## CLARIFICATIONS

**SUBJECT: RECONSTRUCTION OF NATIONAL HIGHWAY N-5 UNDER PAKISTAN'S RESILIENT RECOVERY, REHABILITATION AND RECONSTRUCTION FRAMEWORK PROJECT-PHASE 1A (AIIB FUNDED)**  
**SECTION-2: RANIPUR-ROHRI ROAD (70 KM)**

**RECONSTRUCTION OF NATIONAL HIGHWAY N-5 UNDER  
PAKISTAN'S RESILIENT RECOVERY, REHABILITATION AND  
RECONSTRUCTION FRAMEWORK PROJECT-PHASE I-A (141 KM),  
SECTION-2: RANIPUR-ROHRI ROAD (70 KM),  
L0913-A, IOCT/N-5/PHASE I-A/SECTION-2**

ABUTMENT, WING WALL & ABUTMENT PILE  
REINFORCEMENT  
BRIDGE AT CH. 15+285  
DATE: AUGUST 2025  
DRAWING No. 4825/102/TD/P1G107

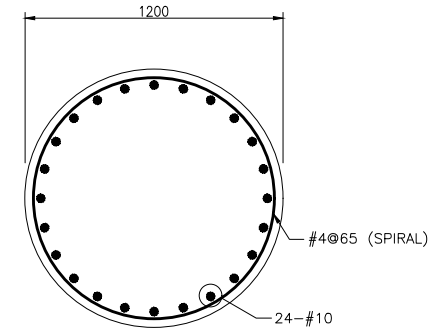
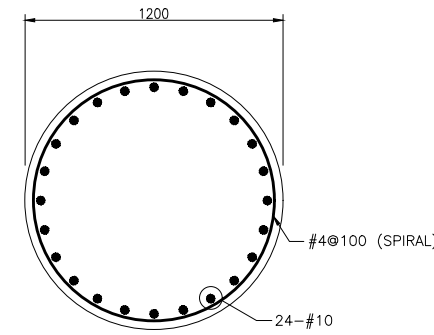
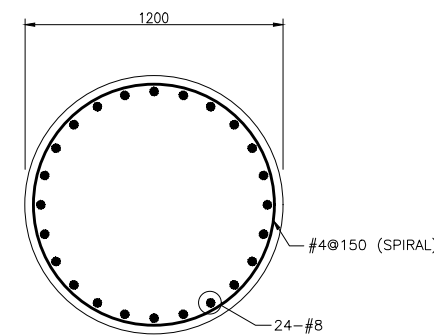
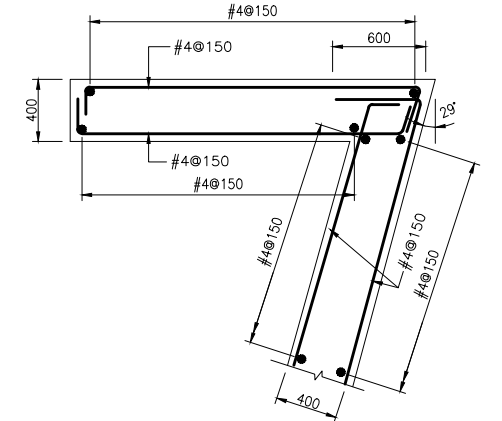
(iii)	The tender drawings do not clearly specify the exact pile foundation lengths and pier column lengths for each bridge structure shown therein. We request NHA to provide the precise dimensions for each bridge, as these are critical inputs for cost estimation and unit rate development.	Revised drawings for each bridge showing pile lengths are attached.  Please refer to <b>Addendum No. 04</b> .

- (a) Tender Drawings No. 4825/102/TD/P1G107 is deleted and replaced with **Annexure No. 01** to Addendum No. 04.
- (b) Tender Drawings No. 4825/102/TD/P1G207 is deleted and replaced with **Annexure No. 02** to Addendum No. 04.

1. FOR GENERAL NOTES REFER DWG. NO. P1G001.
2. READ THIS DRAWING IN CONJUNCTION WITH OTHER RELEVANT DWGS.
3. PROVIDE ONE AND HALF 1½ EXTRA TURNS OF SPIRAL AT THE TOP AND BOTTOM OF EACH PILE & AT EACH SEGMENT OF REINFORCEMENT CAGE OR SPLICE OF MAIN REINFORCEMENT.
4. PILE LENGTH SHOWN IS AS PER GEOTECH REPORT OF THE SAME BRIDGE & SHALL BE FINALIZED AFTER PILE LOAD TEST RESULTS OR AS PER ENGINEER'S DECISION.

ABUTMENT, WING WALL & ABUTMENT PILE REINFORCEMENT BRIDGE AT CH. 44+270		SCALE 1:25
DATE AUGUST 2025	DRAWING No. 4825/102/TD/P1G307	REV.

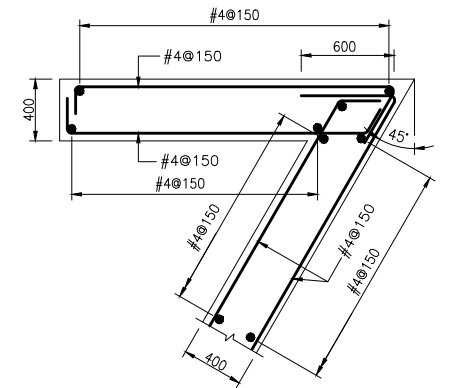
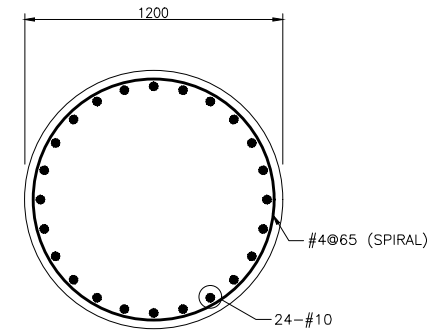
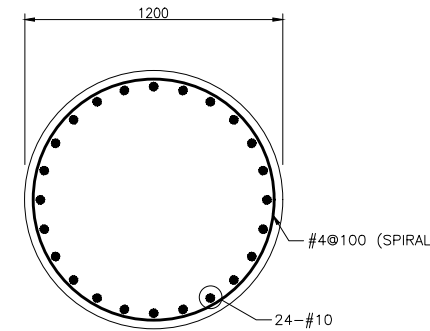
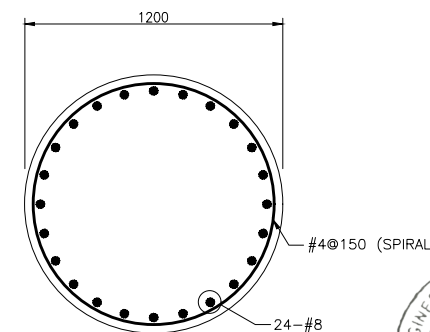
- (c) Tender Drawings No. 4825/102/TD/P1G307 is deleted and replaced with **Annexure No. 03** to Addendum No. 04.
- (d) Tender Drawings No. 4825/102/TD/P1G407 is deleted and replaced with **Annexure No. 04** to Addendum No. 04.

- NOTES: -
- FOR GENERAL NOTES REFER DWG. NO. P16001.
  - READ THIS DRAWING IN CONJUNCTION WITH OTHER RELEVANT DWGS.
  - PROVIDE ONE AND HALF (1 1/2) EXTRA TURNS OF SPIRAL AT THE TOP AND BOTTOM OF EACH PILE & AT EACH SEGMENT OF REINFORCEMENT CAGE OR SPLICE OF MAIN REINFORCEMENT.
  - PILE LENGTH SHOWN IS AS PER GEOTECH REPORT OF THE SAME BRIDGE & SHALL BE FINALIZED AFTER PILE LOAD TEST RESULTS OR AS PER ENGINEER'S DECISION.

ABUTMENT, WING WALL & ABUTMENT PILE REINFORCEMENT BRIDGE AT CH. 59+990		SCALE 1:25
DATE AUGUST 2025	DRAWING No. 4825/102/TD/P1G507	REV.

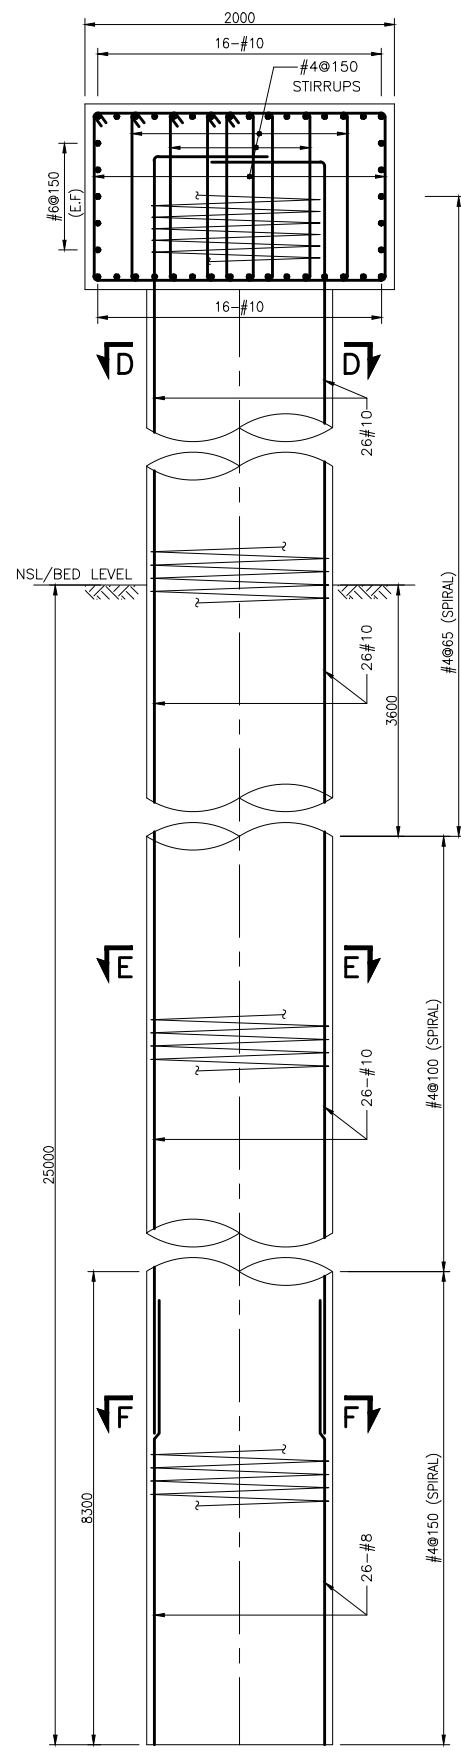
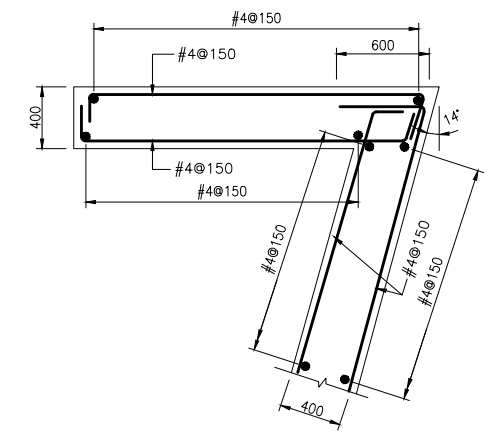
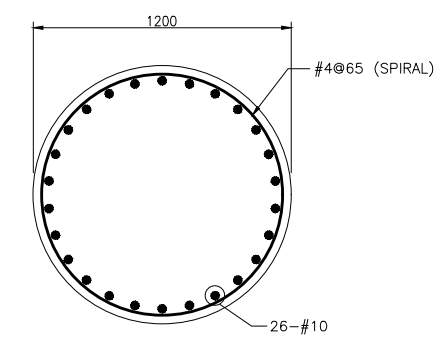
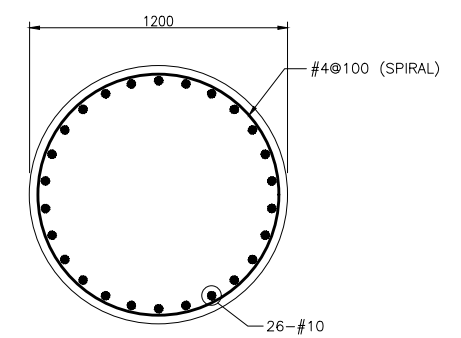
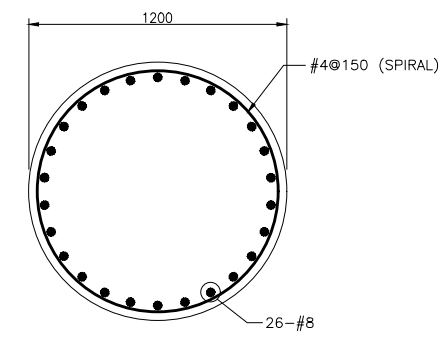
- (e) Tender Drawings No. 4825/102/TD/P1G507 is deleted and replaced with **Annexure No. 05** to Addendum No. 04.
- (f) Tender Drawings No. 4825/102/TD/P1G607 is deleted and replaced with **Annexure No. 06** to Addendum No. 04.

- NOTES: -
- FOR GENERAL NOTES REFER DWG. NO. P1G001.
  - READ THIS DRAWING IN CONJUNCTION WITH OTHER RELEVANT DWGS.
  - PROVIDE ONE AND HALF 1/2 EXTRA TURNS OF SPIRAL AT THE TOP AND BOTTOM OF EACH PILE & AT EACH SEGMENT OF REINFORCEMENT CAGE OR SPLICE OF MAIN REINFORCEMENT.
  - PILE LENGTH SHOWN IS AS PER GEOTECH REPORT OF THE SAME BRIDGE & SHALL BE FINALIZED AFTER PILE LOAD TEST RESULTS OR AS PER ENGINEER'S DECISION..

ABUTMENT, WING WALL & ABUTMENT PILE REINFORCEMENT BRIDGE AT CH. 68+330		SCALE 1:25
DATE AUGUST 2025	DRAWING No. 4825/102/TD/P1G707	REV.

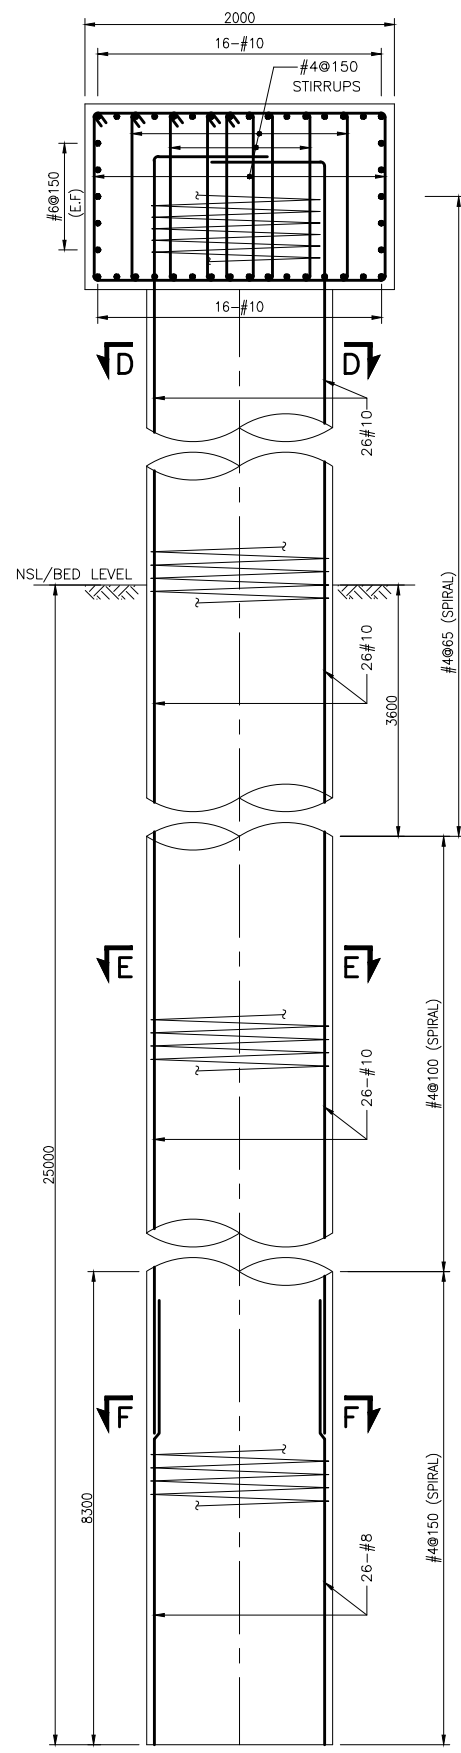
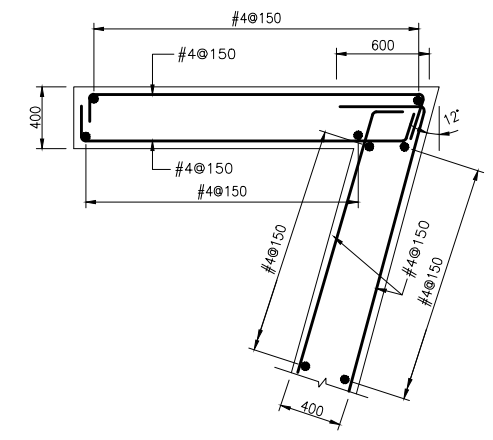
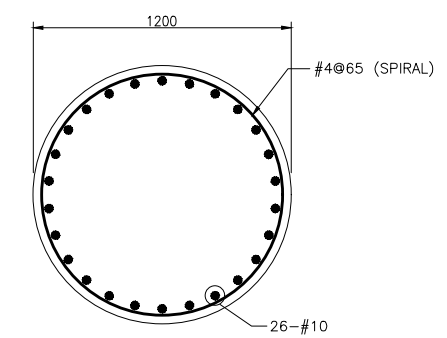
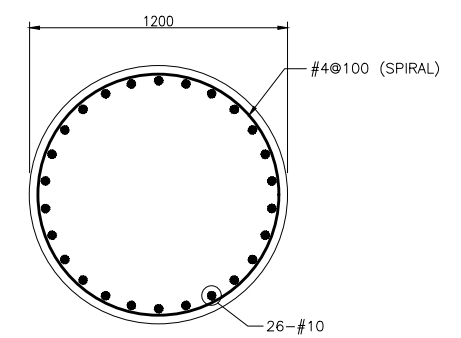
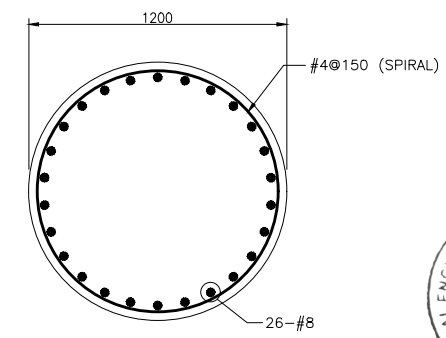
- (g) Tender Drawings No. 4825/102/TD/P1G707 is deleted and replaced with **Annexure No. 07** to Addendum No. 04.
- (h) Tender Drawings related to New Pedestrian Bridges with Pile Foundation are deleted and replaced with updated Drawings as per issued BOQ, Bill no. 4.4: Structures (Pedestrian Bridges) by The Engineer.

- NOTES: -
- FOR GENERAL NOTES REFER DWG. NO. P1G001.
  - READ THIS DRAWING IN CONJUNCTION WITH OTHER RELEVANT DWGS.
  - PROVIDE ONE AND HALF 1 1/2 EXTRA TURNS OF SPIRAL AT THE TOP AND BOTTOM OF EACH PILE & AT EACH SEGMENT OF REINFORCEMENT CAGE OR SPLICE OF MAIN REINFORCEMENT.
  - PILE LENGTH SHOWN IS AS PER GEOTECH REPORT OF THE SAME BRIDGE & SHALL BE FINALIZED AFTER PILE LOAD TEST RESULTS OR AS PER ENGINEER'S DECISION.
